INSTRUCTION TO SERVICE

ITS: 5126

SECTION:	231 Coolant System
WRITTEN BY:	Mike Pearson
SUBJECT:	Replace existing CAC Tube, ISLG

Figure 1: CAC Tube Removal/Installation

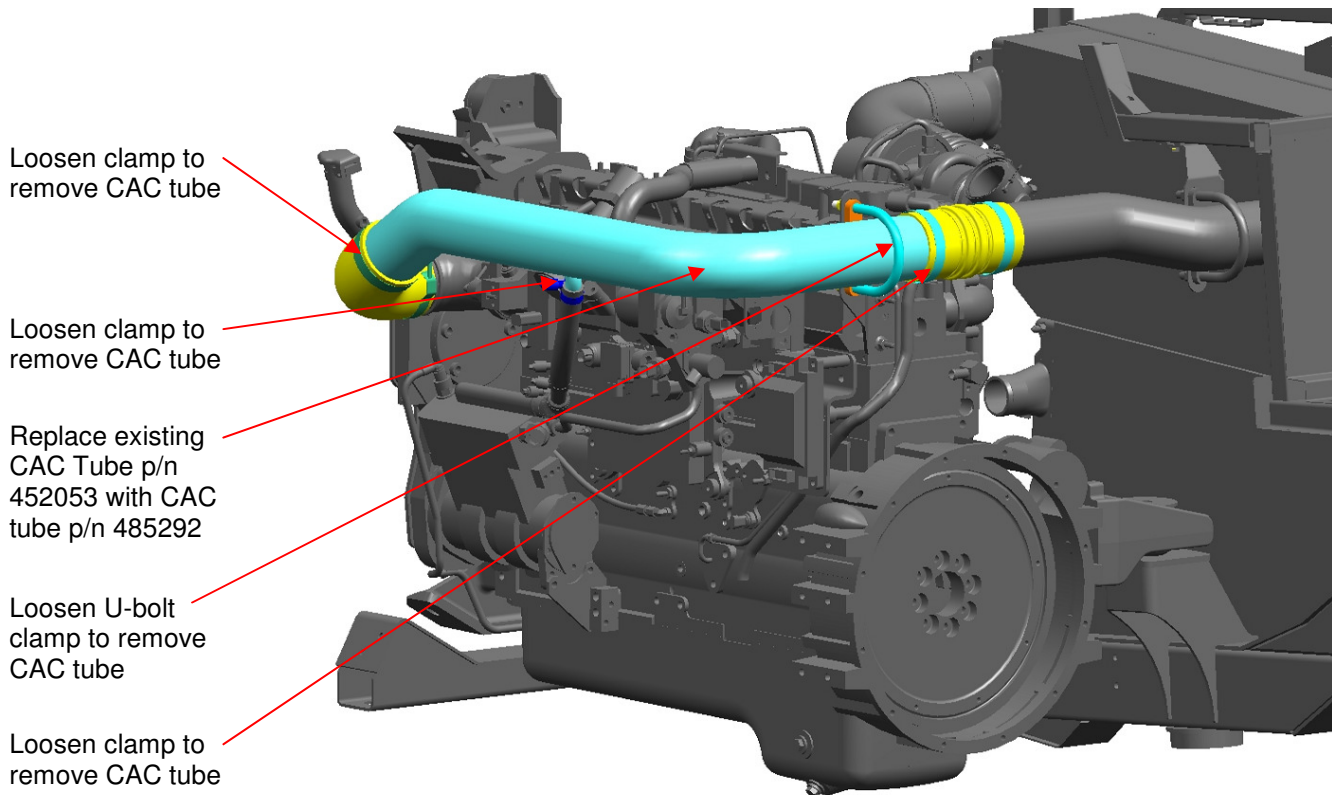
1. Turn the main battery disconnect switch to the "OFF" position.
2. Open the rear engine doors.
3. Open the interior engine access door.
4. Locate the existing CAC tube p/n 425053. See Figure 1.
5. Loosen the U-bolt clamp supporting the tube enough to allow for easy removal of tube. See Figure 1.
6. Loosen the two existing T-bolt clamps holding the tube to the 4" elbow and hump hose and the breeze clamp securing the hose from the air compressor to the tube. See Figure 1.
7. Remove the existing CAC tube and replace with new CAC tube p/n 485292. See Figure 1.
8. Re-install the clamps removed in Step 6. Torque to 80-90 in*lbs.
9. Re-tighten the U-bolt loosened in Step 5.
